PROJECT NO. 57236

**ENCHANTED ROCK’S COMMENTS IN RESPONSE TO COMMISSION STAFF’S
QUESTIONS
ON THE TEXAS BACKUP POWER PACKAGE PROGRAM RESEARCH ENTITY
FINAL REPORT**

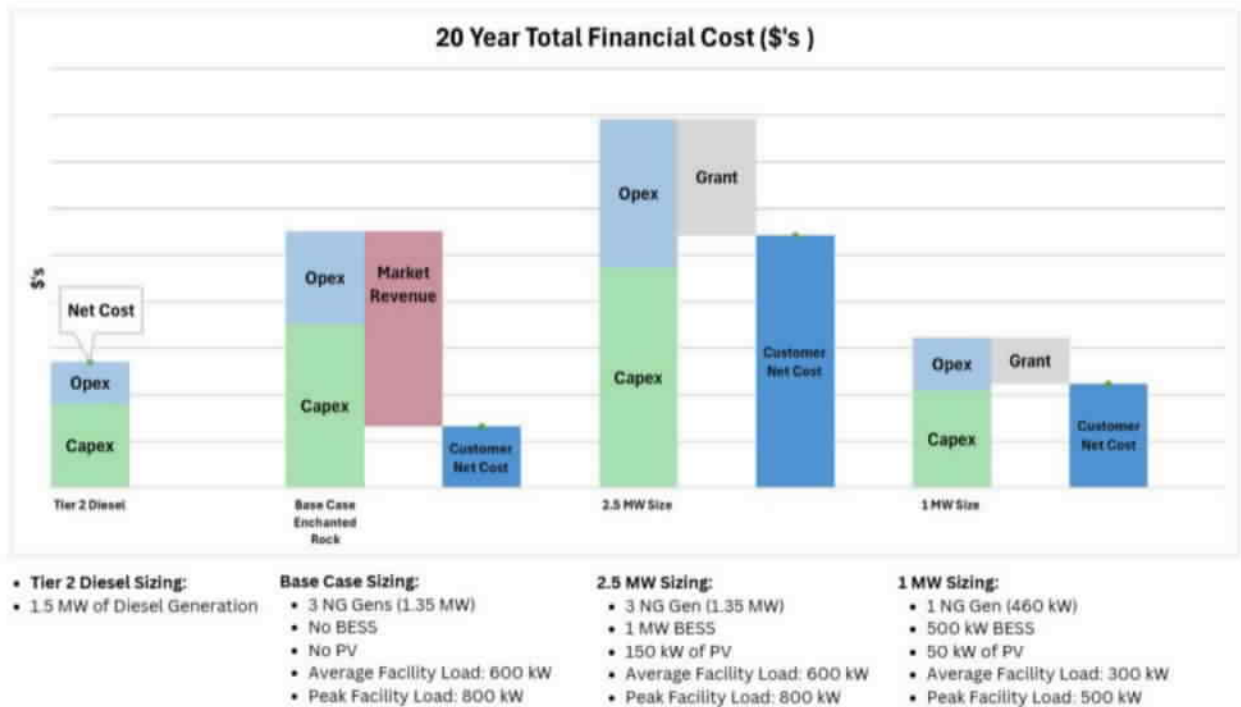
In support of GRIT’s comments, Enchanted Rock is providing the following charts to illustrate the financial breakdown of various system sizing and monetization options for the BPP program over a 20-year period using representative technology options that are available on the market. The Capex (capital expenditure) bar represents the upfront cost of the system, which includes the application of the Investment Tax Credit (ITC) for solar and other eligible components. The Opex (operational expenditure) bar reflects the ongoing costs to maintain and operate the system over its lifespan. The Market Revenue demonstrates the revenues generated from displacing site load through a combination of generators, photovoltaic (PV) systems, and

battery energy storage systems (BESS), effectively lowering the customer contribution. (To be clear, Market Revenue in this case does not include any disqualifying revenues from participating in the ERCOT market as energy or ancillary services.) The Grant section represents the BPP grants of \$500/kW, which further reduces the Capex and makes the solutions more affordable for the customer.

The graph above highlights the stark differences in customer net costs between a traditional Tier 2 diesel setup, Enchanted Rock’s standard model, and two different sizing configurations under the BPP program parameters. While Enchanted Rock’s base case leverages market revenue to significantly offset costs, the BPP scenarios result in much higher customer contributions, even with grant funding. Notably, reducing the number of generators from three to one in the smaller BPP configuration, and thereby reducing inherent resiliency of redundant equipment, still fails to bring customer net costs down to a level that is competitive with Enchanted Rock’s base case. If one were to use Patrick Engineering’s numbers, it is easily deduced that, even at the very low end of the cost spectrum for proposed TBPP configurations, \$1,200/kW less the \$500/kW incentive results in a \$700/kW TBPP, which is still more expensive than procuring a Tier 2 diesel backup generator readily available in the market for \$500-600/kW. This underscores the economic challenge posed by the current BPP design requirements,

particularly in the absence of revenue-generating opportunities to offset costs. Ultimately, the program, as proposed by Patrick Engineering’s report, will have little to no traction in the market as critical facilities will have no economic incentive to depart from the status quo.

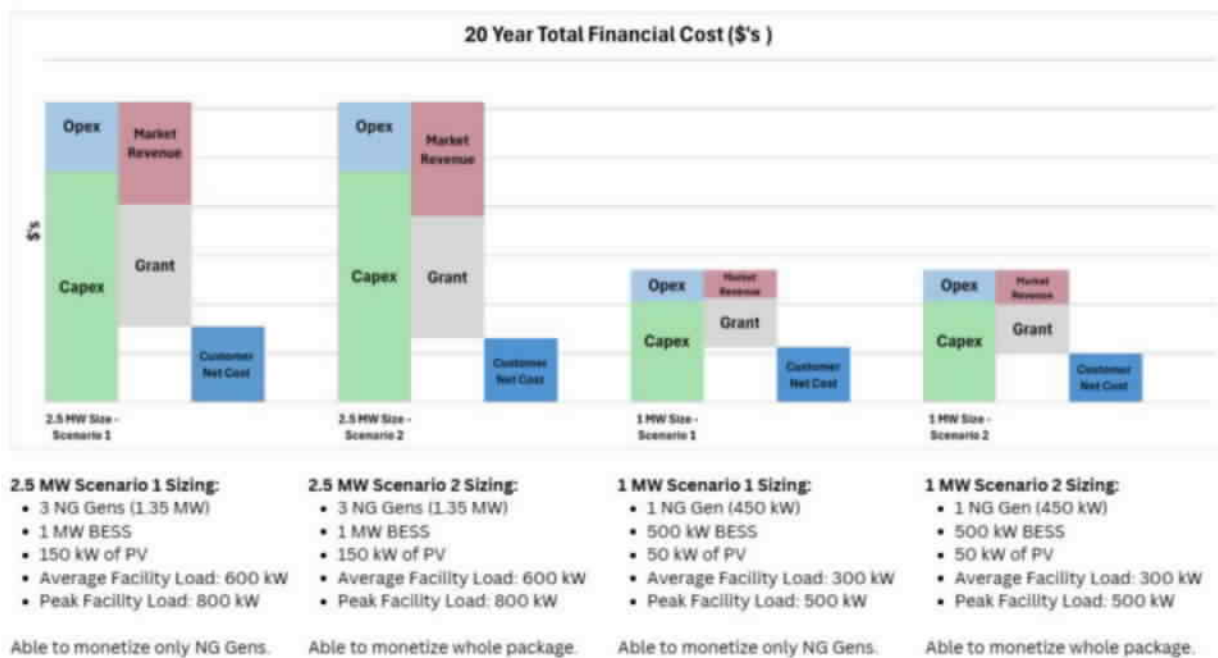
The above graph demonstrates the significant impact of monetization on improving project economics under the BPP program. Monetizing the natural gas generators alone helps significantly reduce customer net costs, improving the overall viability of the projects. However, monetizing the full package – including natural gas generators, BESS, and solar PV – further lowers costs for customers, highlighting the critical value of enabling revenue generation from all system components. The grant funding plays a key role in offsetting upfront costs, but its impact alone is insufficient to make the packages competitive with traditional backup solutions unless all components can contribute to revenue generation. These findings emphasize the need for program flexibility to maximize the economic viability of these systems for customers.

The Commission should clarify that the prohibition on Backup Power Packages being used for the “sale of energy or ancillary services” is specifically related to Energy & Ancillary Services as defined in the ERCOT protocols. Services that TBPPs can provide outside the ERCOT markets are crucial for the economics of the program to be workable for developers and customers alike.
